Project:
Goodyear Total Tyres
Warehouse Facility
Site Address:
LOT 205 on SP2955994

LANDSCAPE PLANS APPROVED

Application No.: **OPW/2022/1618**

Landscape Operational Works SPECIFICATION & PLANTING SCHEDULE

Drawing No: 6098-L-PR1-PP1 Rev. No: D

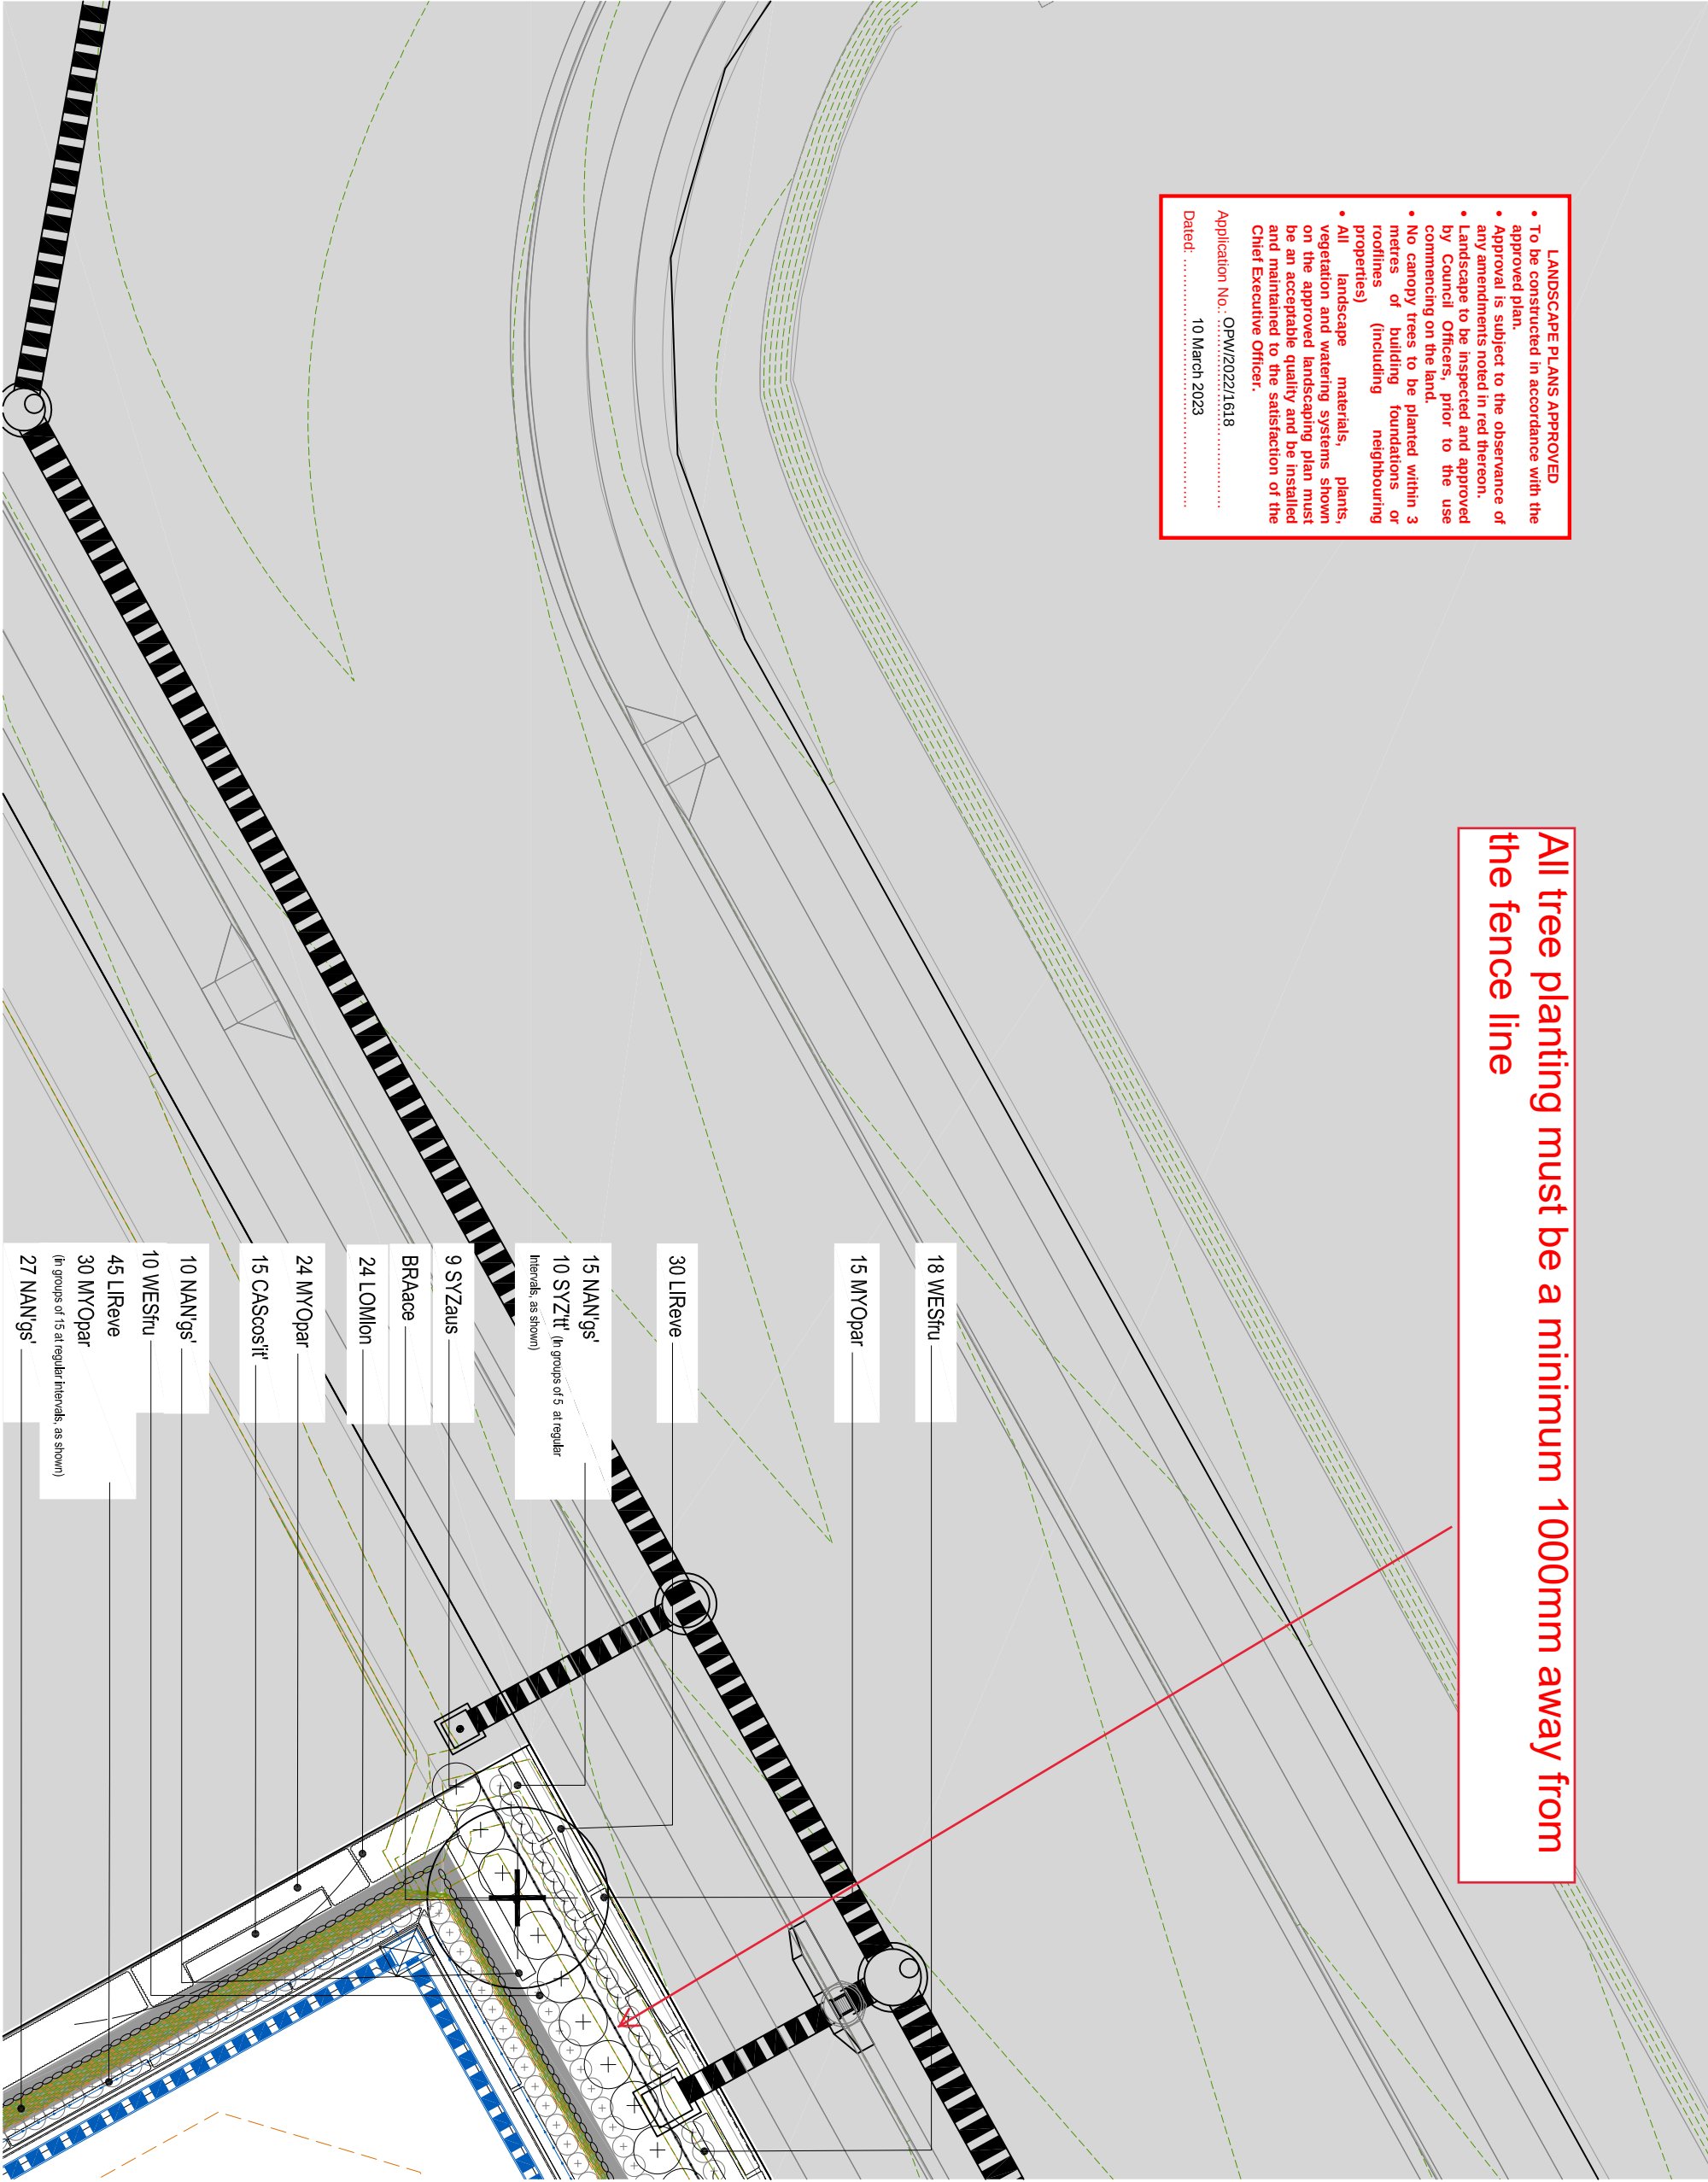
All tree planting must be a minimum 1000mm away from the fence line

Drawing No: 6098-L-PR1-PP12 Rev. No: D

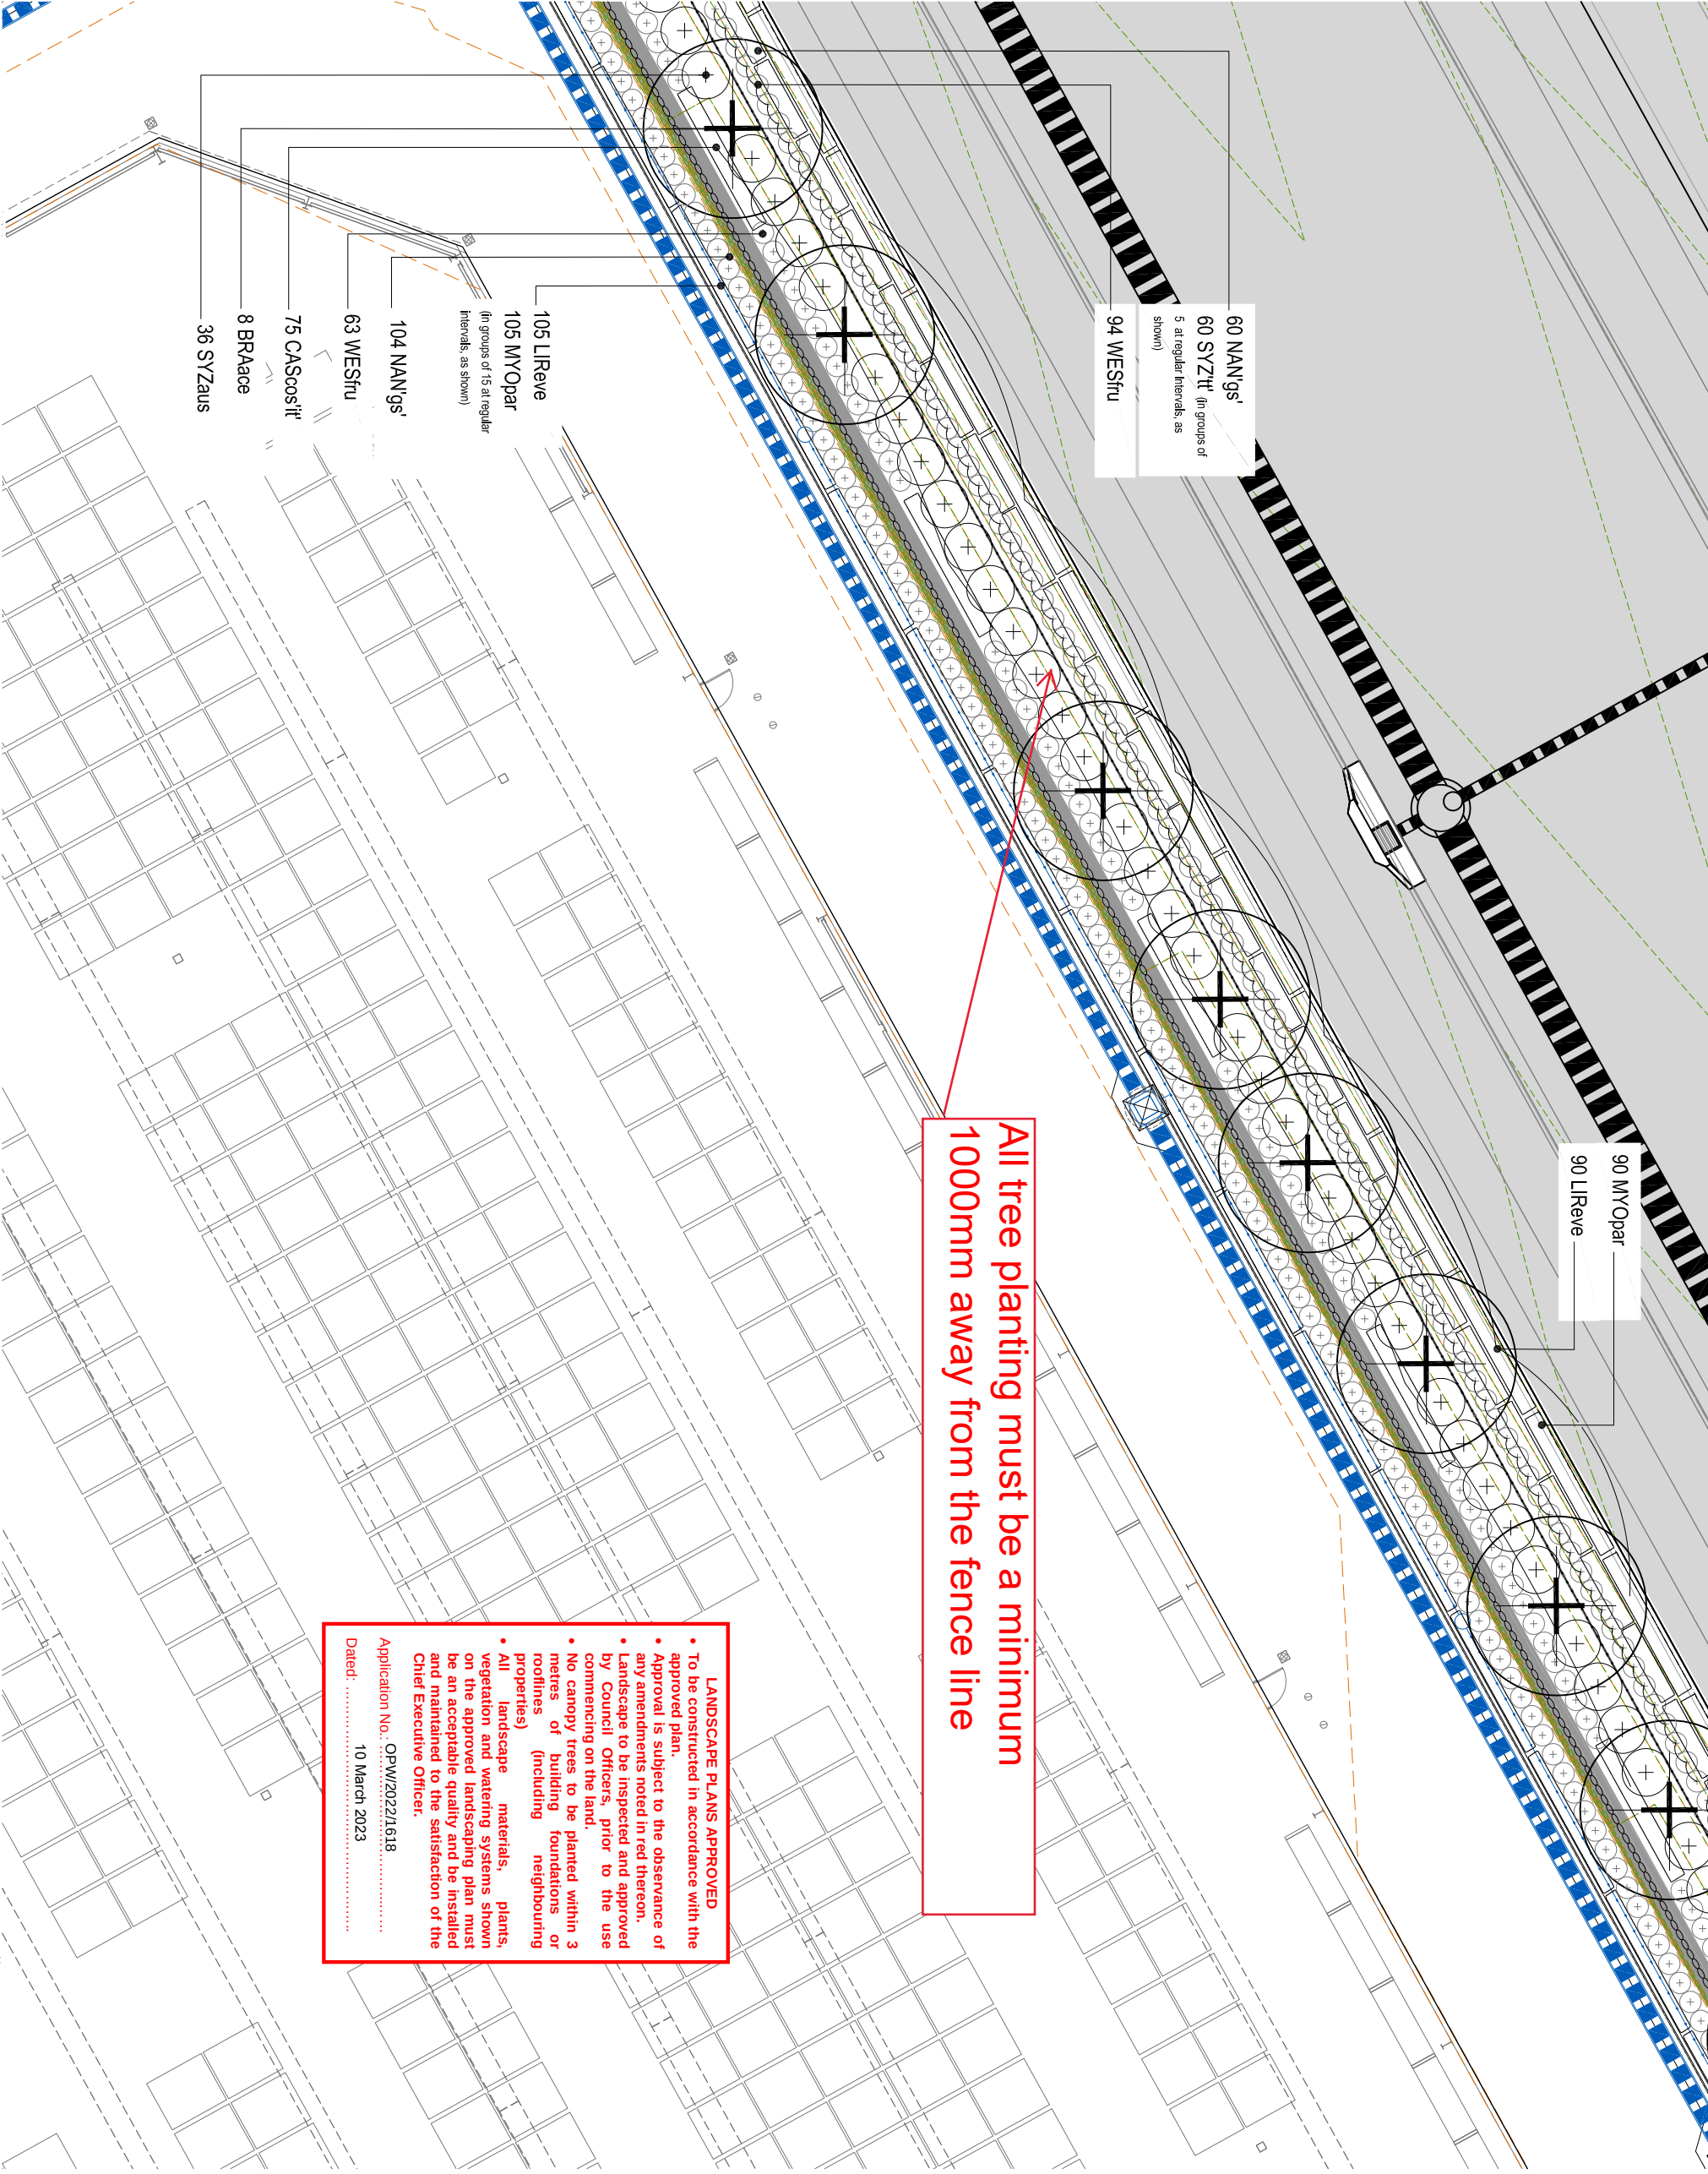
All tree planting must be a minimum
1000mm away from the fence line

Drawing No: 6098-L-PR1-PP13 Rev. No: D

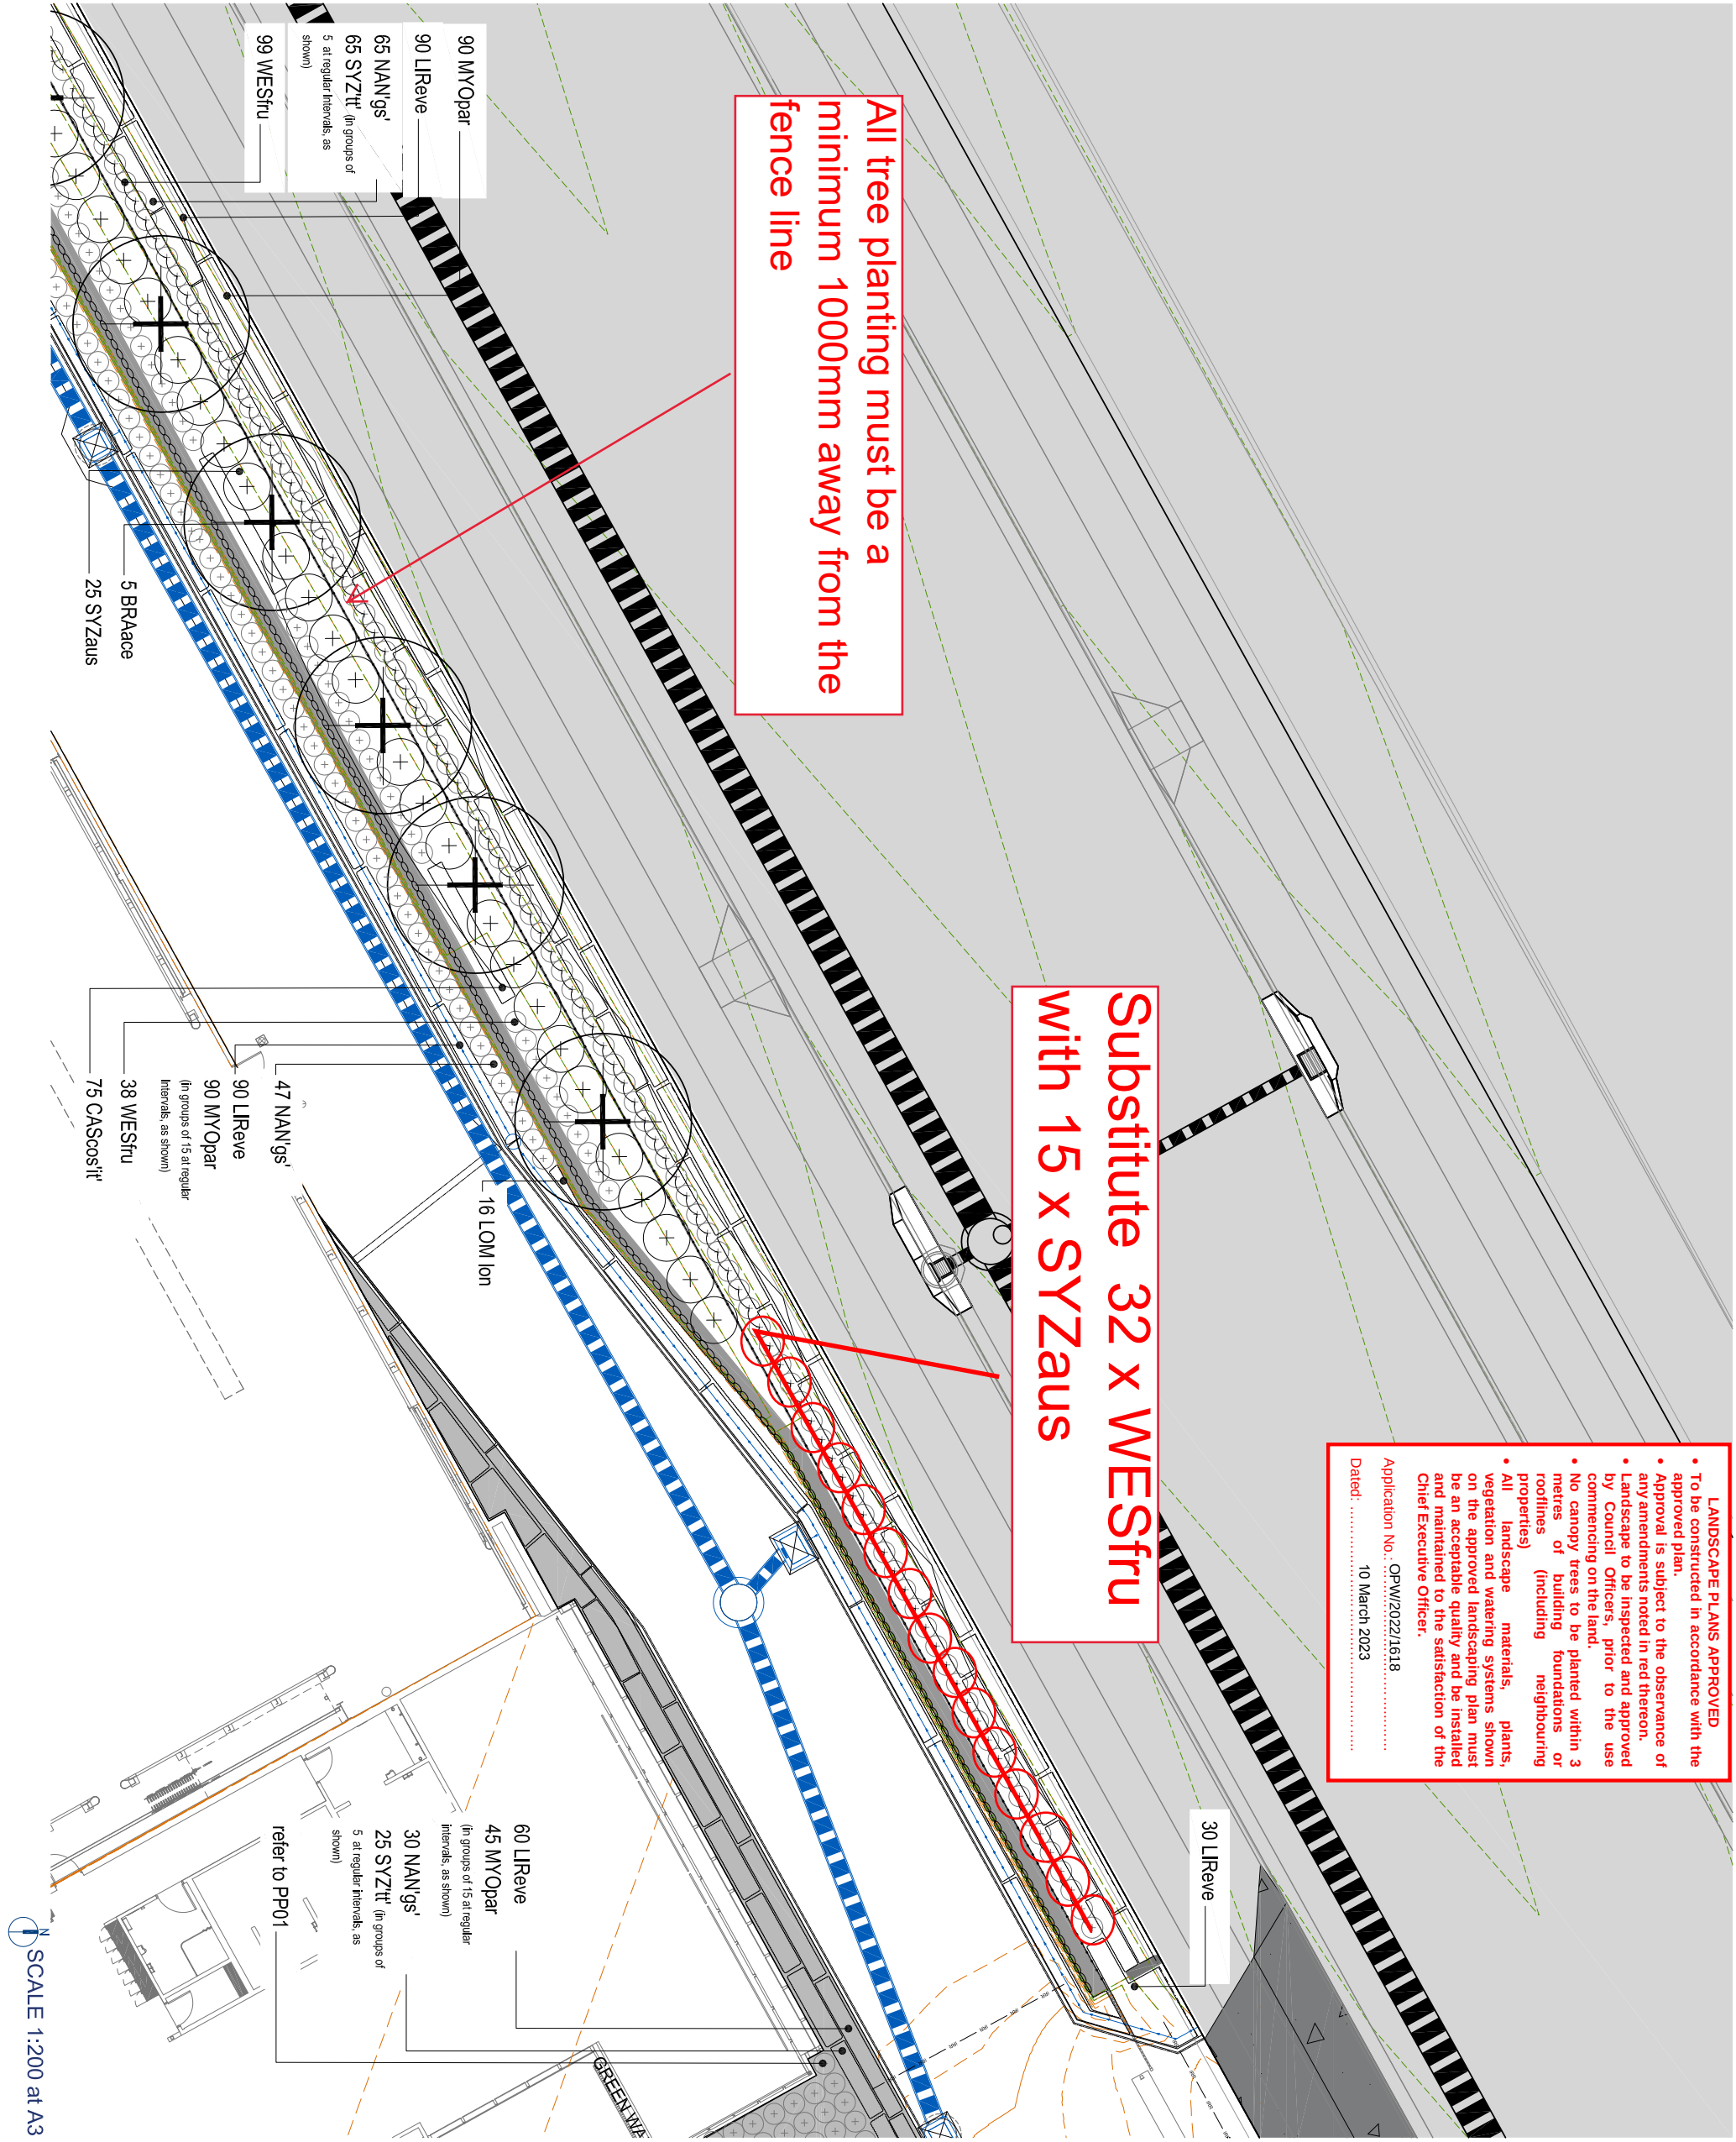
All tree planting must be a
minimum 1000mm away from the
fence line
